Project Name: * R-5014-Widening of SR1217 from dead end to US158

Subject: **Request for Minor Modification of the CAMA Major Development Permit** for the widening of SR 1217 (Colington Road) from Dead End to US 158 (Croatan Highway) in Dare County, North Carolina; TIP Project R-5014, Federal Aid Project No. STP-1217(6); Debit \$100 from WBS Element 41162.1.1

Reference: CAMA Major Development Permit #125-18 issued November 5, 2018

The NCDOT is requesting a Minor Modification for CAMA Major Development Permit #125-18.

PERMIT DRAWING
SHEET 32 OF 41

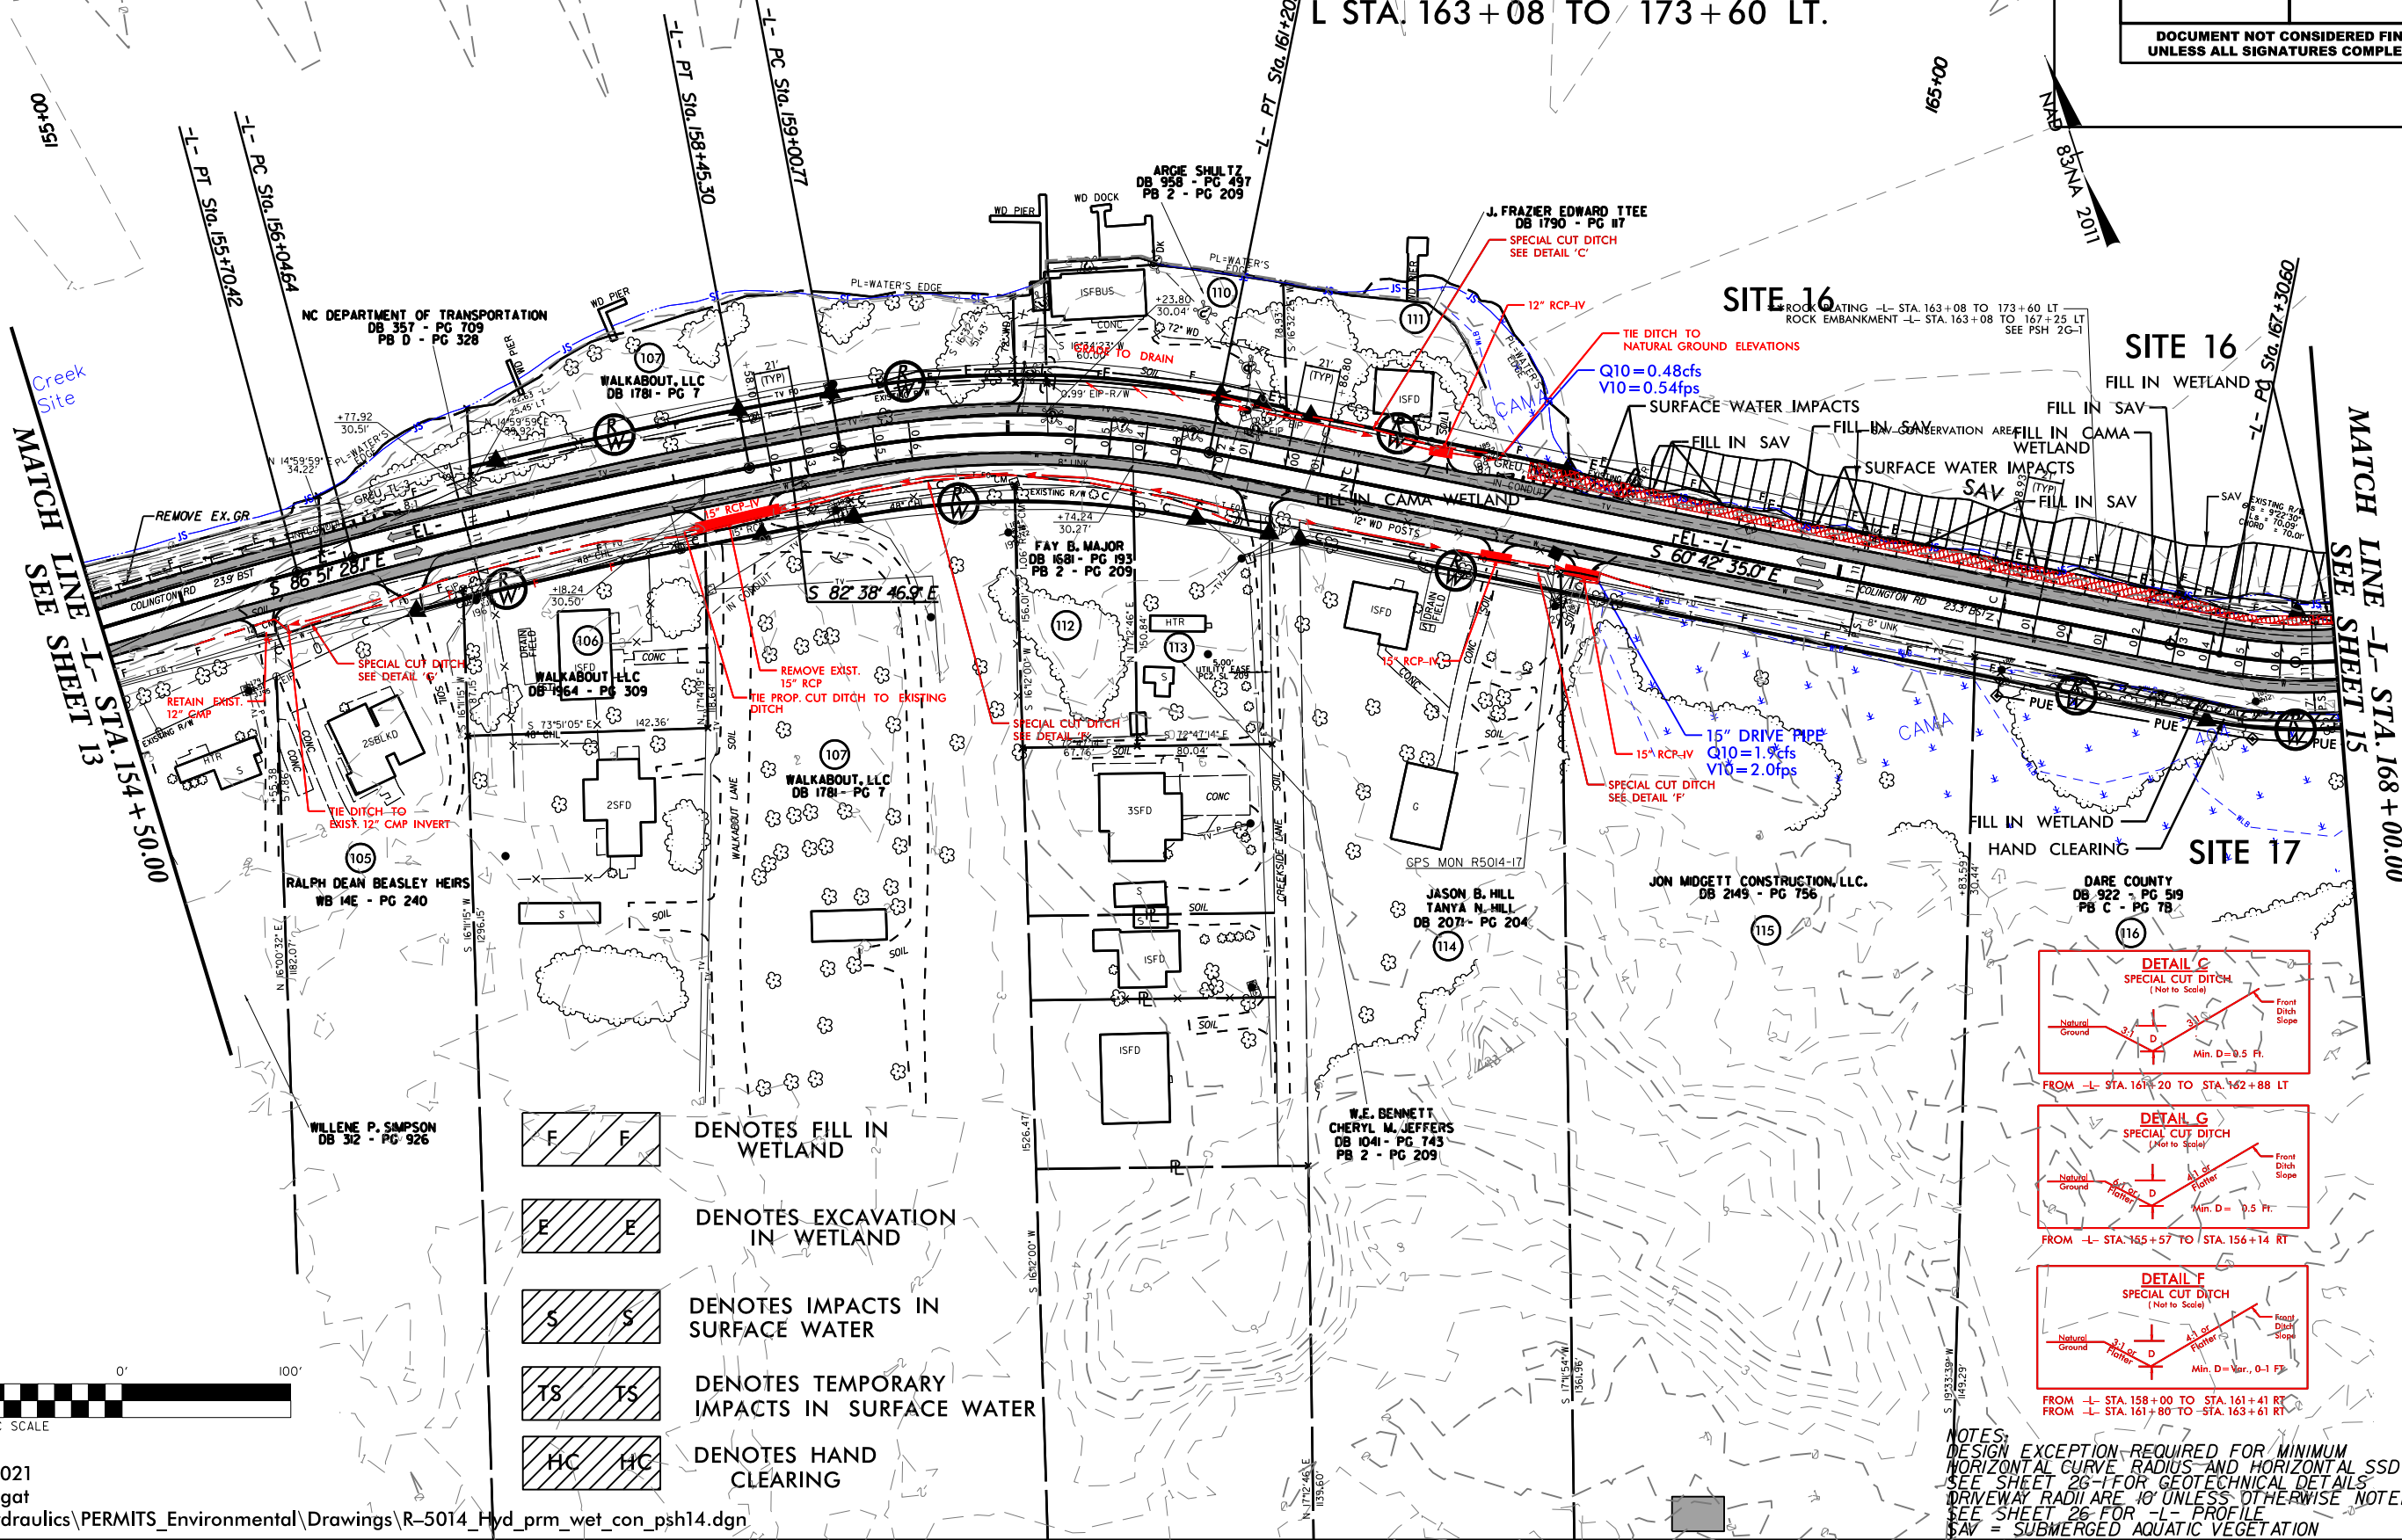
Sites 16 & 18 163+08 to 173+60 LT, rock embankment / rock plating

2:1 SLOPES USING ROCK PLATING FROM
L STA. 163+08 TO 173+60 LT.
